NUREG-2246

Fuel Qualification for Advanced Reactors

APPENDIX B ANALYSIS OF PUBLIC COMMENTS

Figure 3-1 Composition of the Main Goal

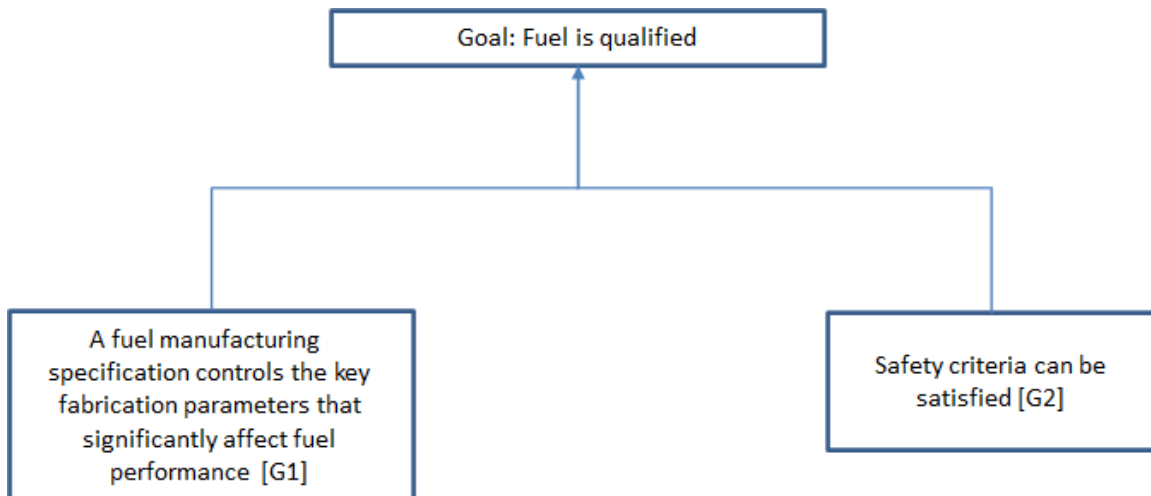
The main goal decomposition does not seem correct (Fig. 3.1). G1 and G2 not only goals for fuel qualifications. The manufacturing process and safety criteria vs. qualification? Truly not sure about it. Can you formalize, which "fabrication parameters significantly affect" what? At the same time, below "complete manufacturing specification is not expected as part of the licensing documentation"...

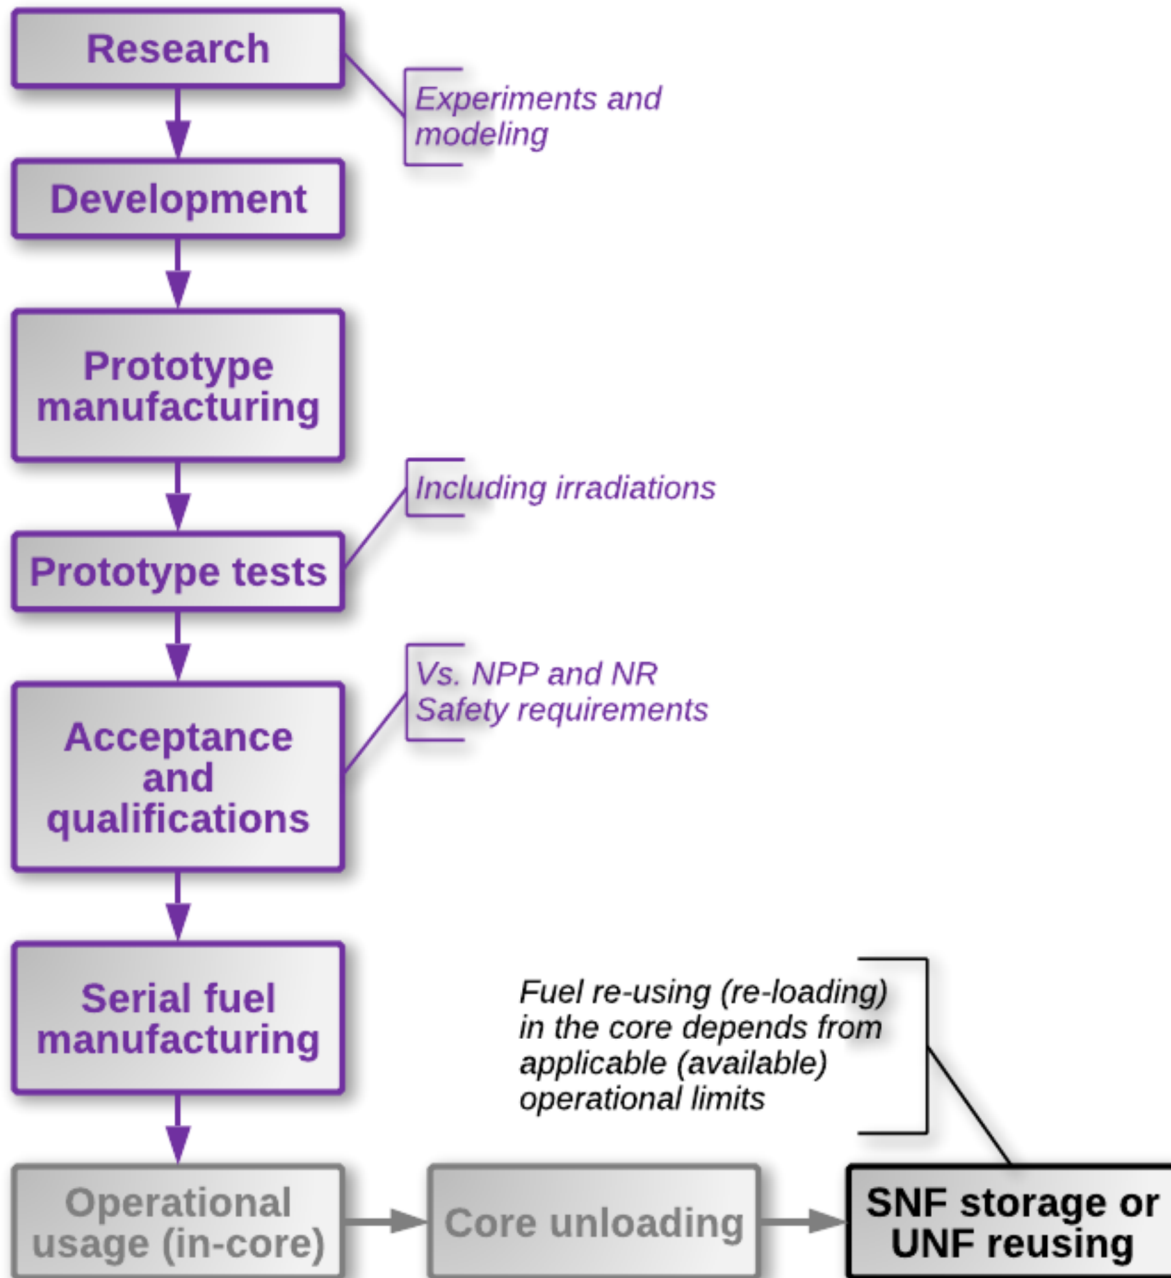
That is, all descriptions, diagrams, and tables A-2 and A-3 do not make much sense and not related to fuel qualification process.

In Table A-1, all block names must be clearly identified with the diagrams and should be the same. A single large diagram will be more useful than separate blocks of it because this diagram could present the logic of the process.

I am working on logic now and will present it my remarks additionally. I understand your logic, but this logic does not look perfect for such important document. Diagram block G.2.1.1 has connections to two different blocks (for example). But these blocks are different in nature and cannot be substantiated simultaneously. Otherwise, this is not correct from the technical point of view.

Regarding the listing in Table A-1, “List of Goals in Fuel Qualification Assessment Framework,” NRC staff paraphrased the complete description of some goals for brevity.

The NRC staff made no changes to NUREG-2246 in response to this comment.

Comment No. 3-7

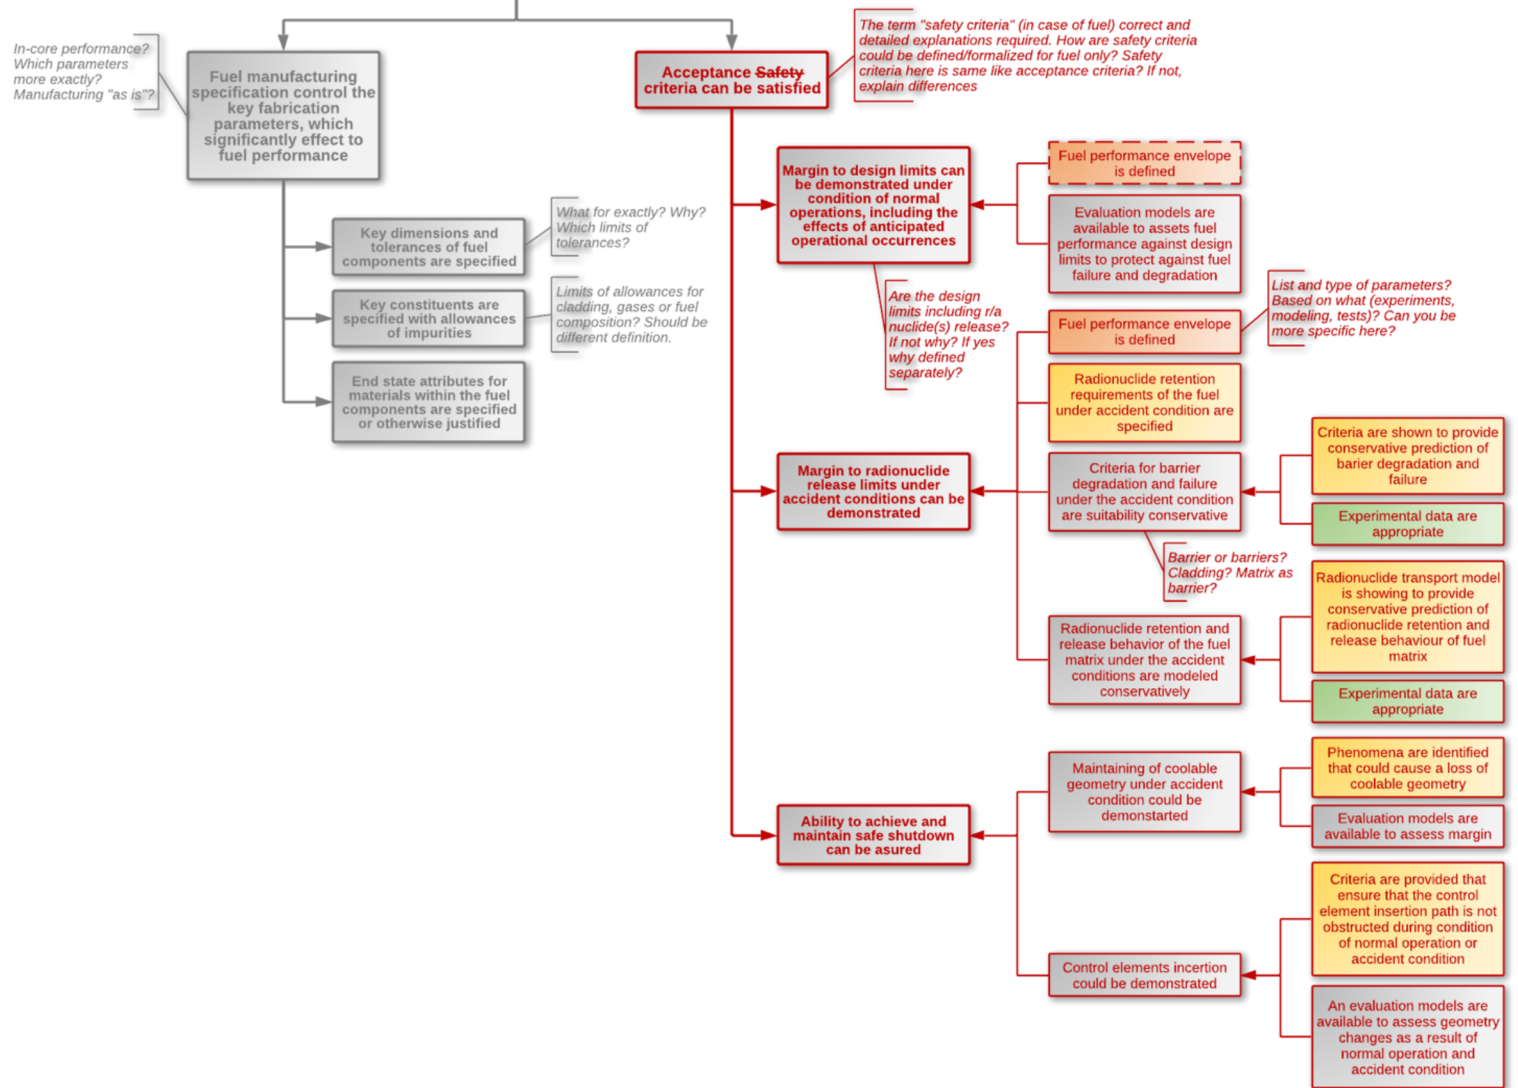
Additional remarks about your document would be presented on diagram (see below).
